Submission for Job: #6010 SSD 6010 - One Residential Building (Student Accommodation) within Darling Drive Plot

Site: #2824 SICEEP Site, The Haymarket; Darling Drive, Sydney

**SSD 6010 - One Residential Building (Student Accommodation) within Darling Drive Plot**

**LEVEL 6**

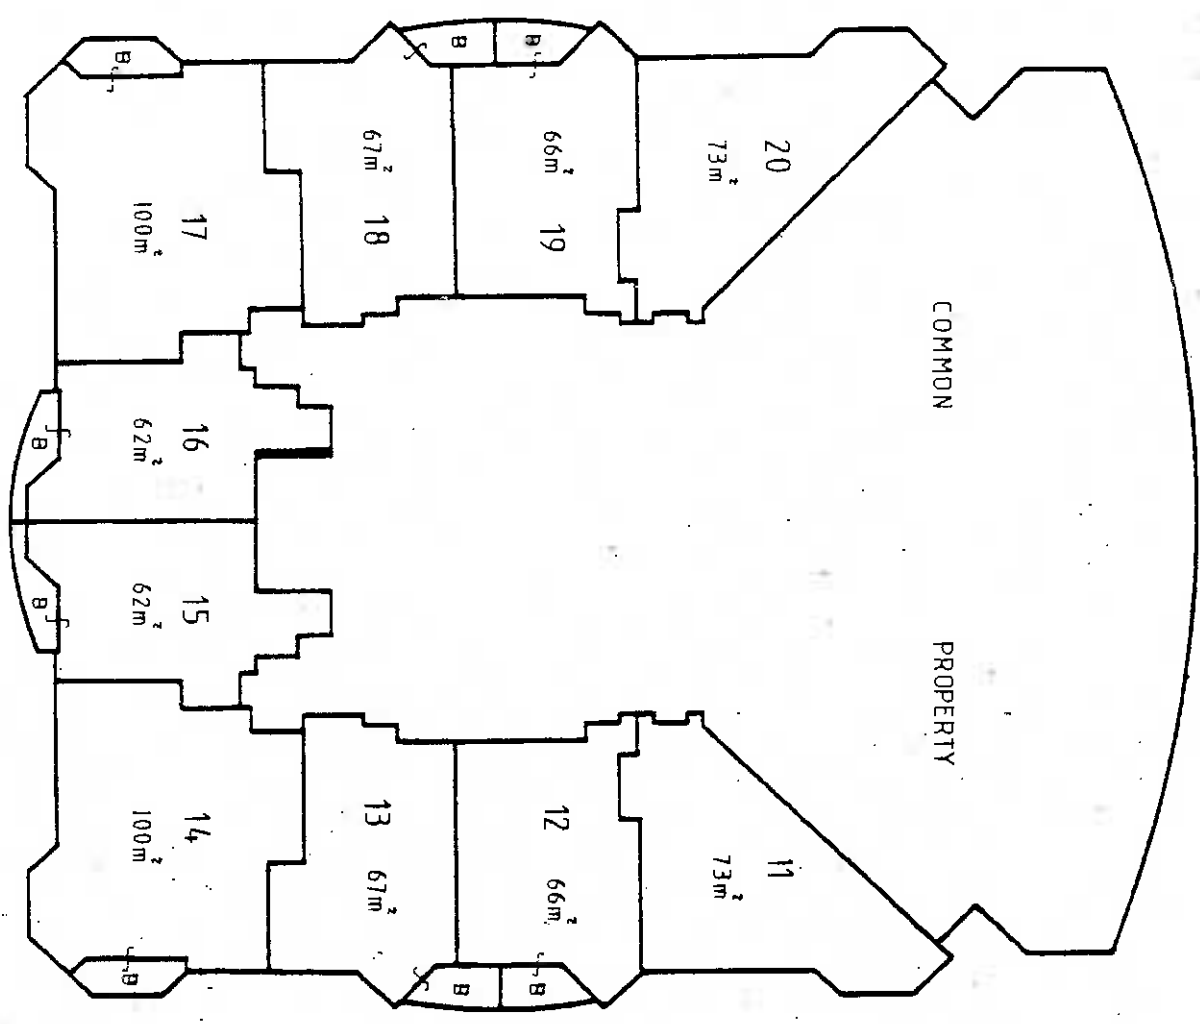
Levels 6 and 7 each contain two apartments with single west aspect , i.e. 4 single aspect apartments.

LEVEL 8

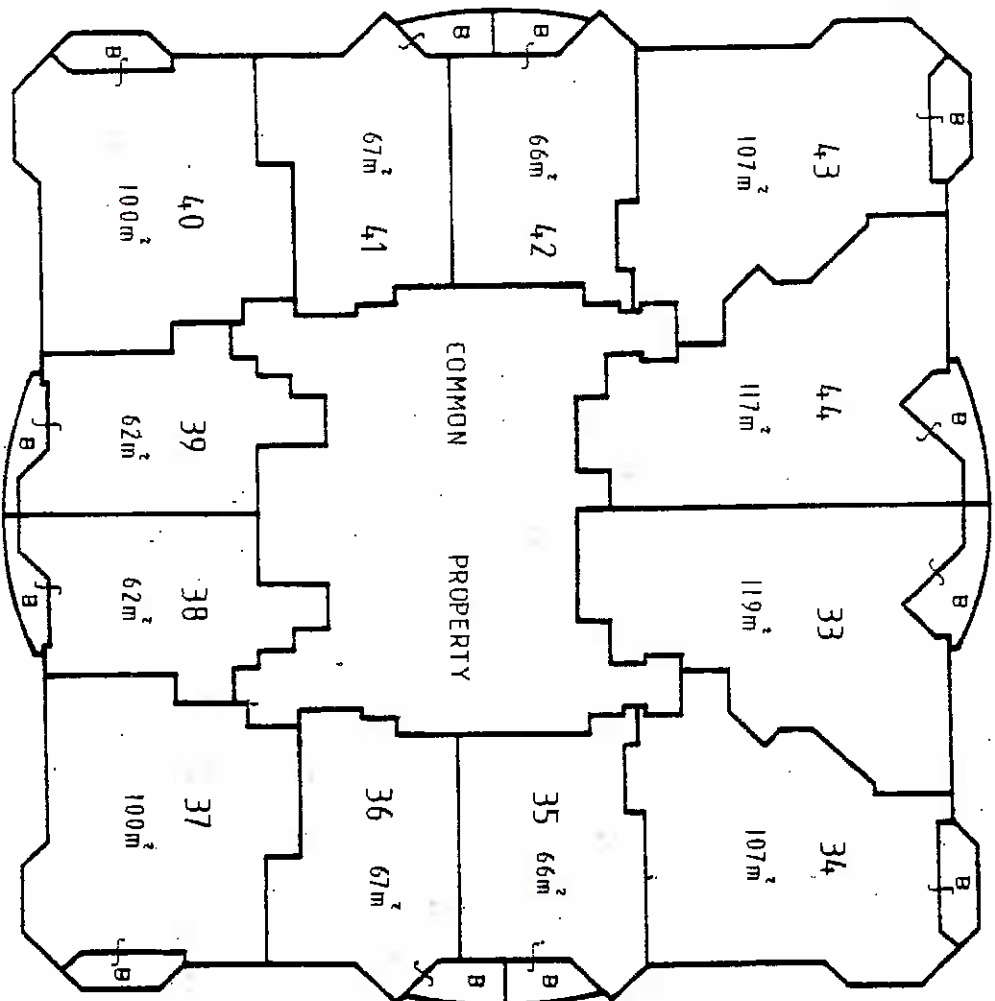
Levels 8-15 each contain two apartments with single west aspect and two apartments with single north aspect , i.e. 4 single aspect apartments per level, giving 32 single aspect apartments.
